ARCHITECTURAL REVIEW APPROVAL REQUEST FORM

HOA OF LYNN LAKE

Property Address: 10910 Lynn Lake Circle

PATIO ADDITION AND SIDE WALKS
~~501~~ 10910

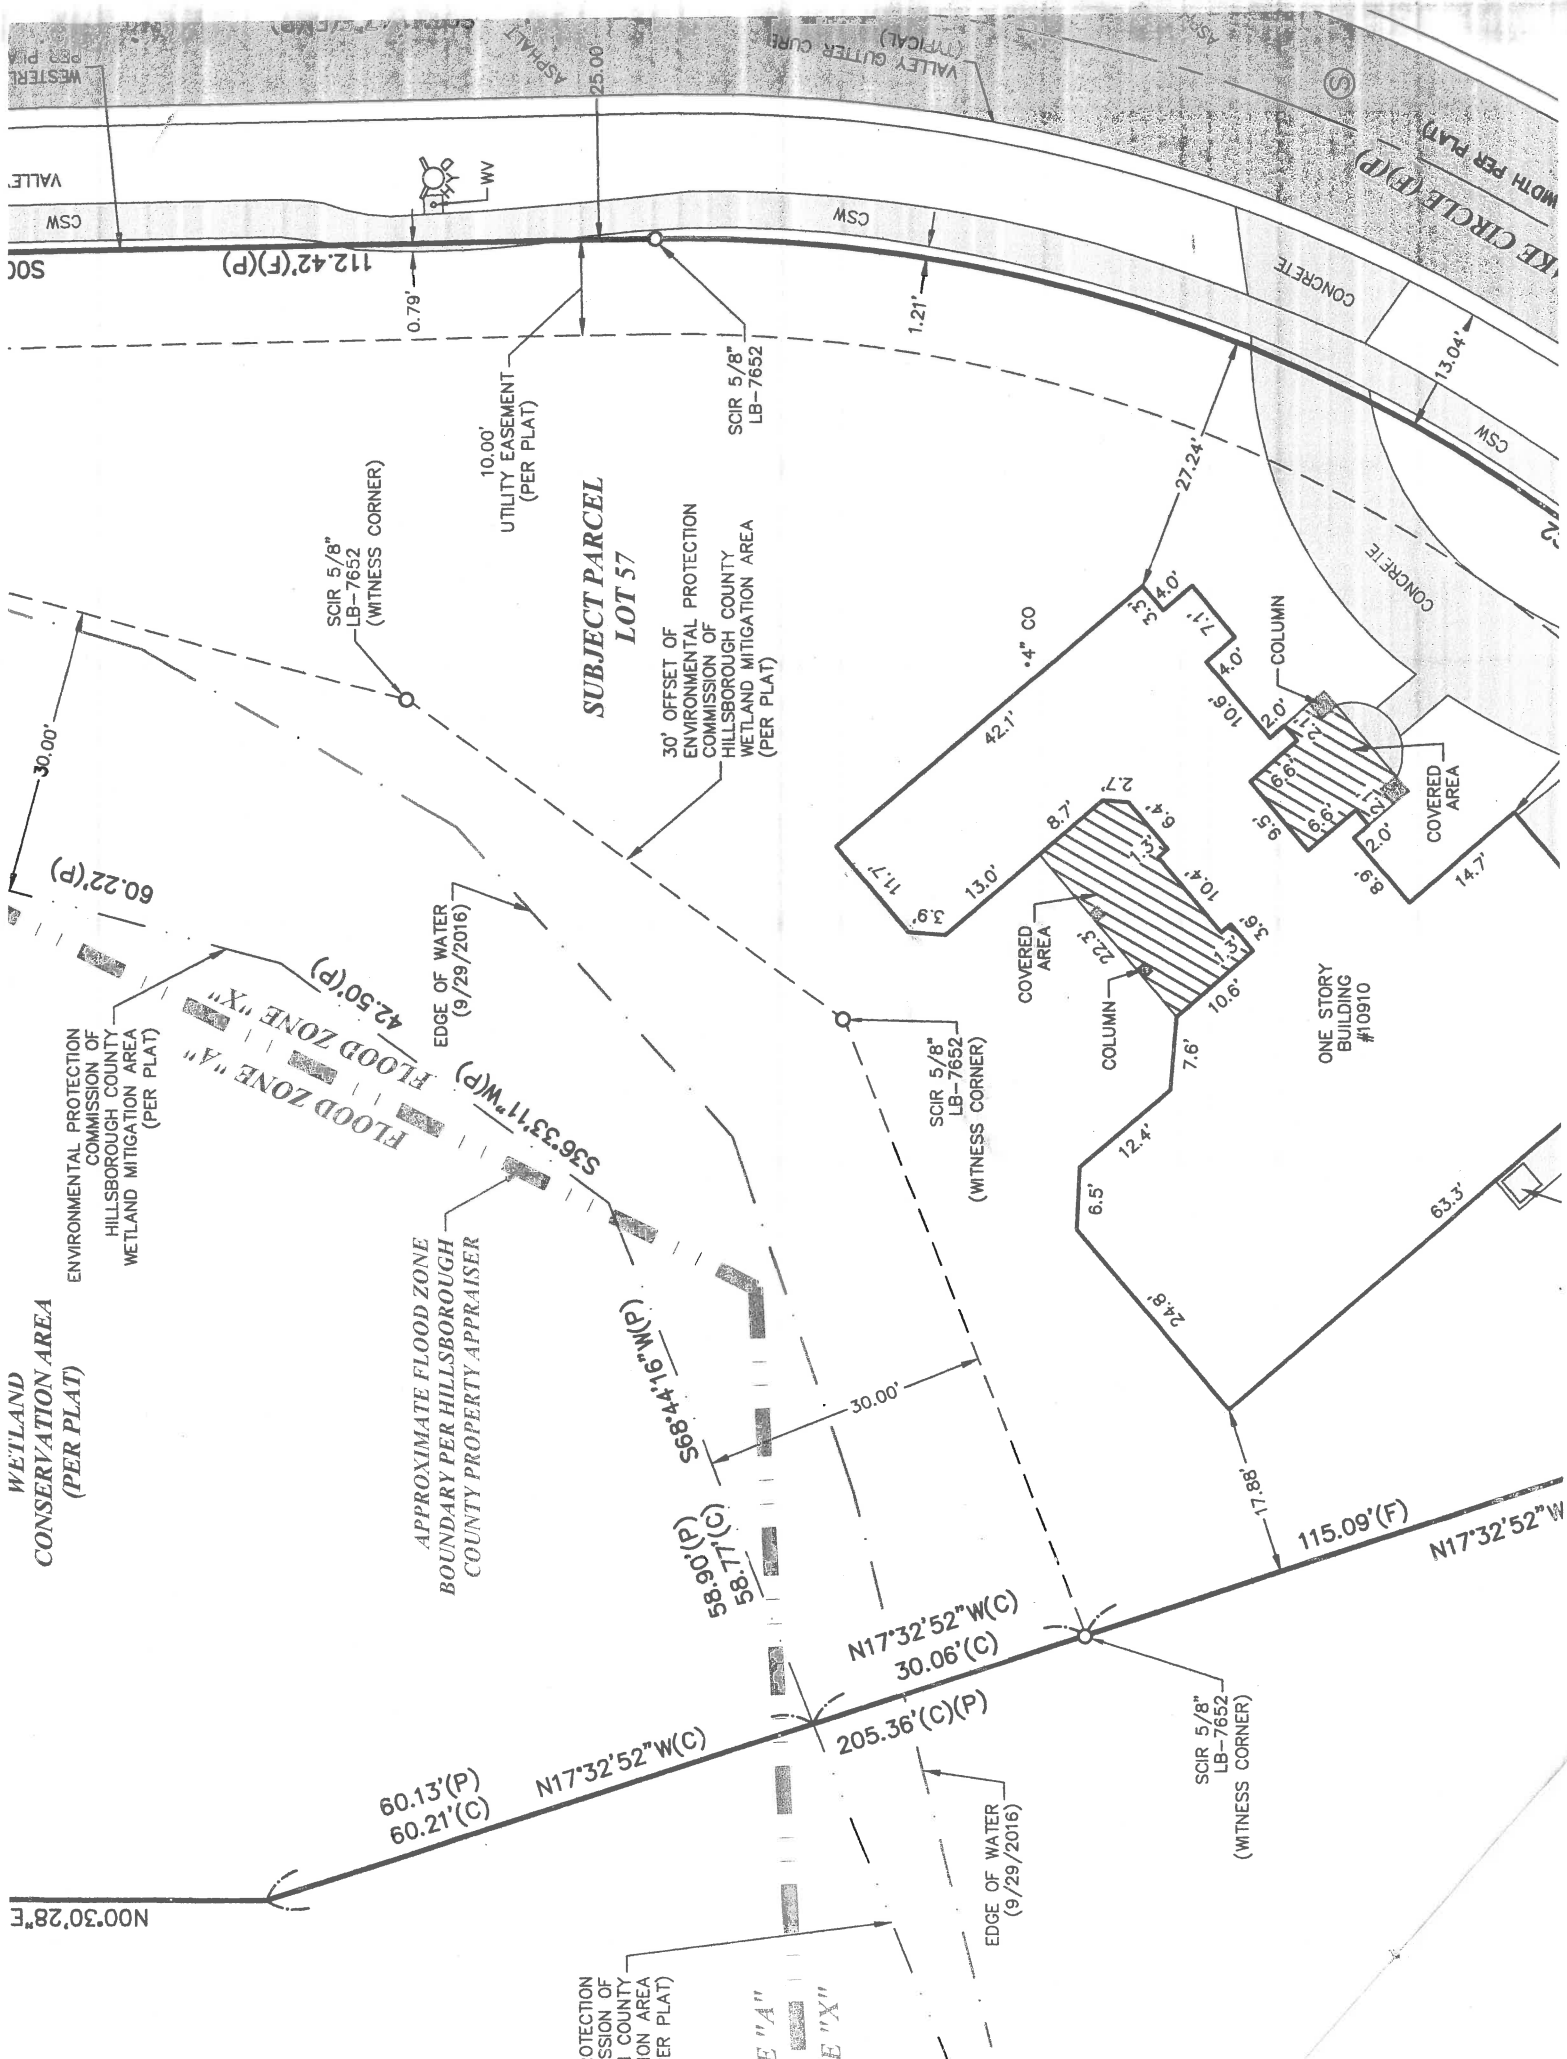
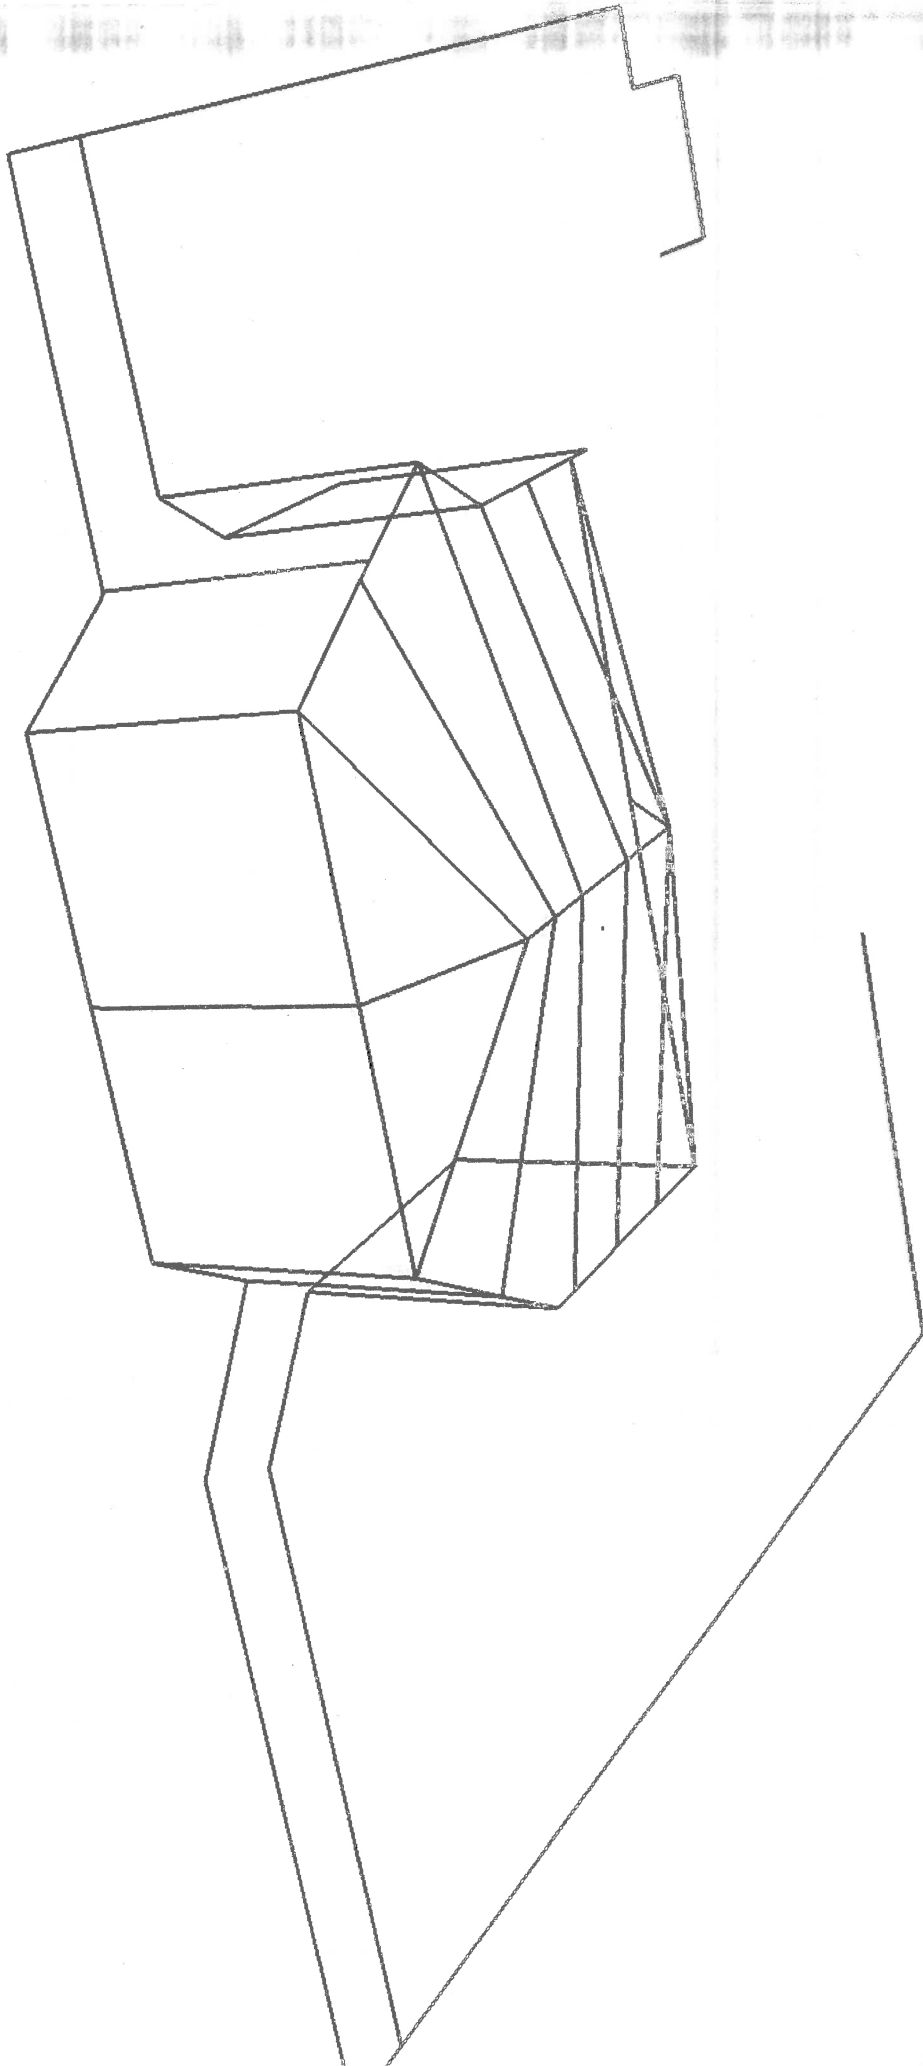
Conditions: Please provide your contractor's information and estimated date of project.
